Item ID: D206-667-203TRN

Item Name: Crosstube Turning Detail

DART AEROSPACE LTD	Work Order: 107547
Description: Crosstube Assembly	Part Number: D206-667-243
Inspection Dwg: D206-667-243 Rev: C	Page 1 of 2

DRAWING NO. D206-667-243	TITLE CROSSTUBE ASS'Y (206L HIGH AFT)	REV. C	DART AEROSPACE LTD ENGINEERING ORDER		D.E.O. NO. D206-667-243-C-1	SHEET NO. SHEET 1 OF 1	SCALE NTS
DRAWN <i>qp</i>	CHECKED <i>ASS</i>	MFG. APPR. <i>RB</i>	APPROVED <i>MD</i>		DE APPR. <i>#</i>		
DATE 11.07.15	DATE 11.07.20	DATE 11.07.21	DATE 11/07/21		DATE 11.07.21

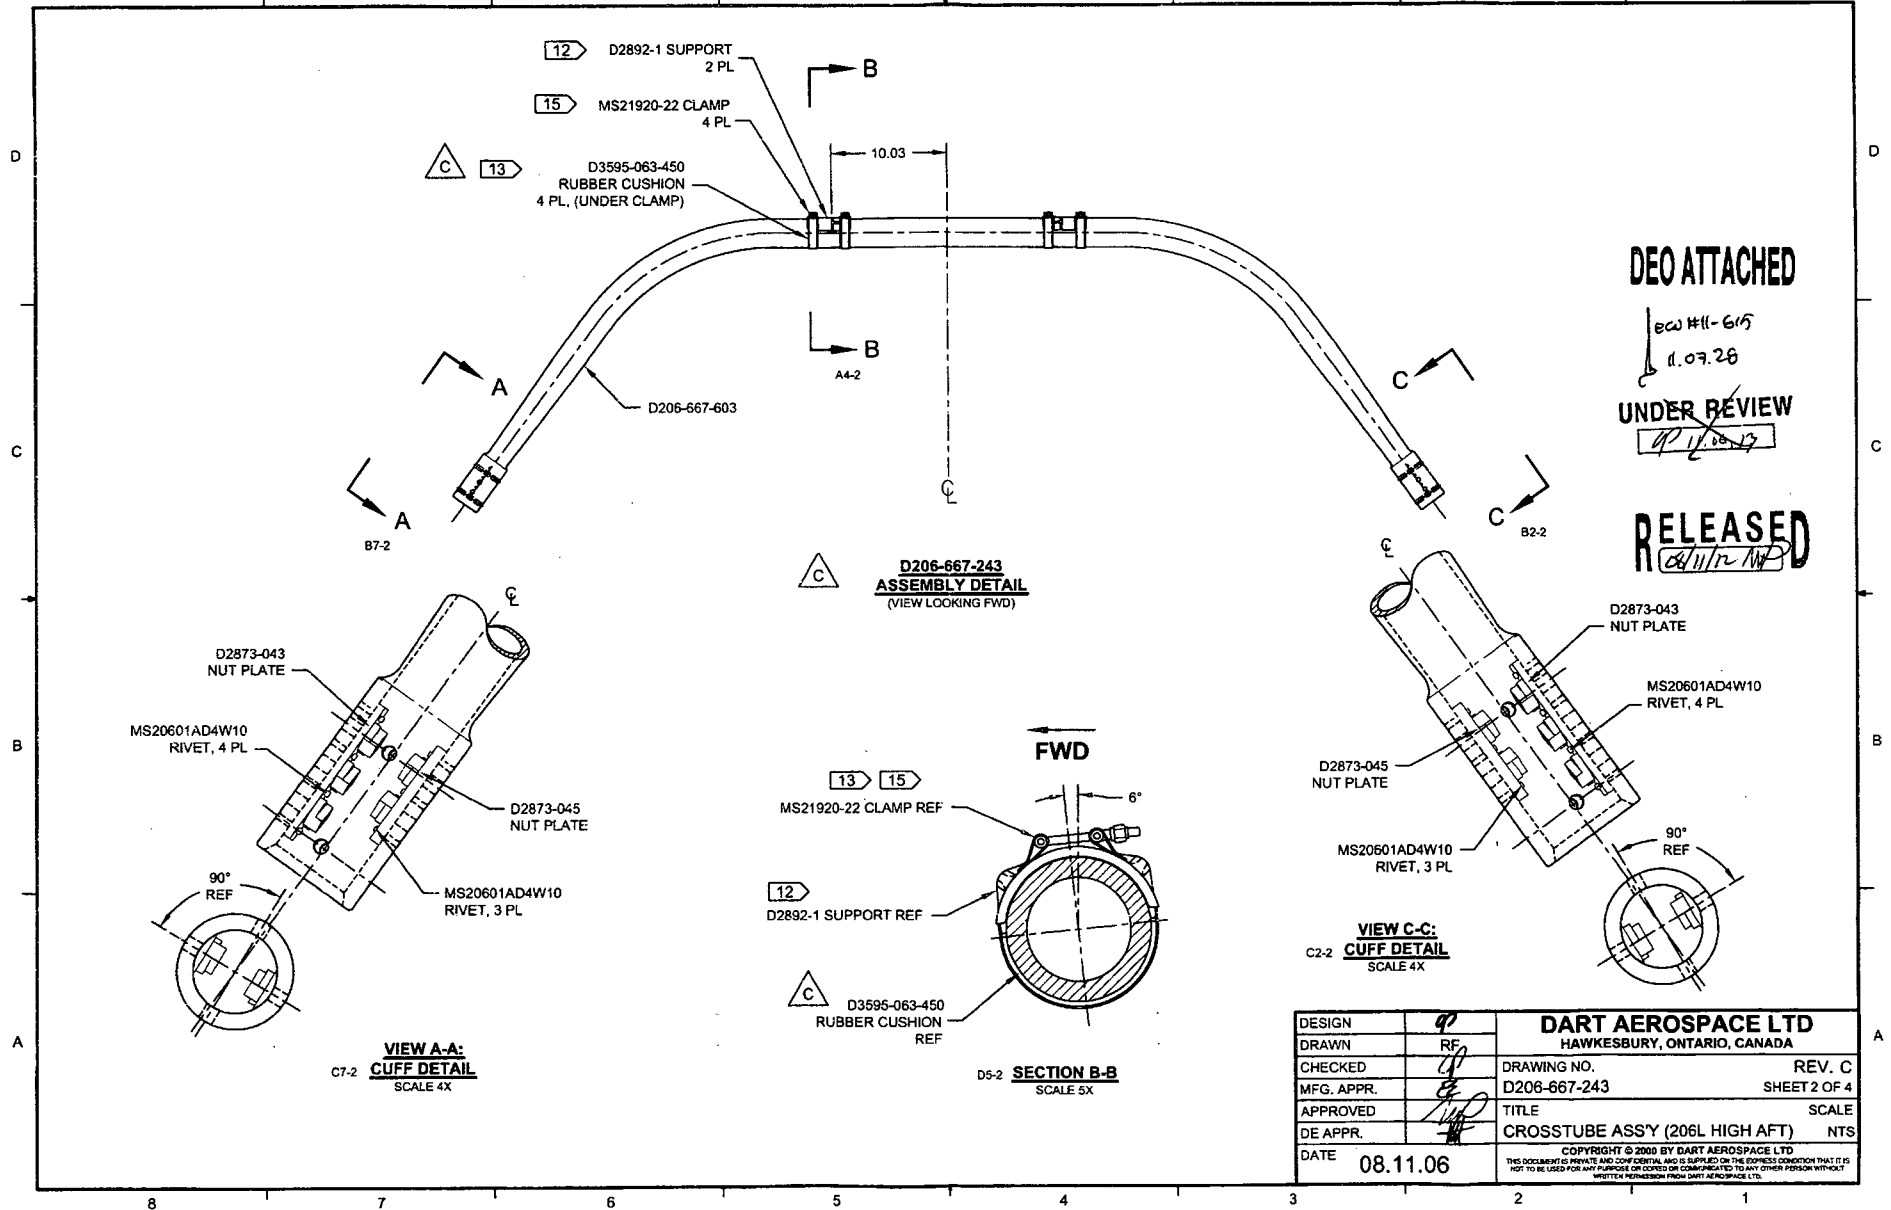
REPLACE MAGNOBOND WITH PROSEAL.

CHANGE:**IS:**

Item	Qty -243	Part Number	Description
9	A/R	PROSEAL 890 B-2	SEALANT, AMS-S-8802 CLASS B-2

NOTE 12 & 15, SHEET 1 IS AMENDED AS FOLLOWS:

- 12) TO INSTALL D2892-1 SUPPORT: ABRASE MATING SURFACE OF SUPPORT AND CROSSTUBE WITH 180-GRIT SANDPAPER AND REMOVE RESIDUE WITH MEK (OR EQUIVALENT). APPLY A 0.04" TO 0.07" THICK LAYER OF PROSEAL 890 CLASS B-2 (OR AMS-S-8802 CLASS B-2) SEALANT TO MATING SURFACE OF SUPPORT.
- 15) TORQUE CLAMPS 80 TO 100 IN-LB. ENSURE AT LEAST 1.5 THREADS SHOWING IN SAFETY AND THAT NUT HAS NOT BOTTOMED-OUT AFTER TORQUING. **PRIOR TO PACKAGING, RE-CHECK TORQUE ON CLAMPS AFTER PROSEAL 890 SEALANT HAS CURED FOR 72 HOURS.**

WAS:

9	A/R	MAGNOBOND 6398	ROCKWELL SPECIFICATION RBO-120-023 ADHESIVE (TEXTRON/BELL SPEC. 299-947-100, TYPE II, CLASS 2 ADHESIVE)
---	-----	----------------	---

WAS:

- 12) INSTALL D2892-1 SUPPORT USING 0.03" TO 0.06" THICK LAYER OF MAGNOBOND 6398 PER QSI 015. LET CURE FOR 12 HOURS AFTER INSTALLATION AND PRIOR TO PACKAGING.
- 15) TORQUE CLAMPS 80 TO 100 IN-LB. ENSURE AT LEAST 1.5 THREADS SHOWING IN SAFETY AND THAT NUT HAS NOT BOTTOMED-OUT AFTER TORQUING.
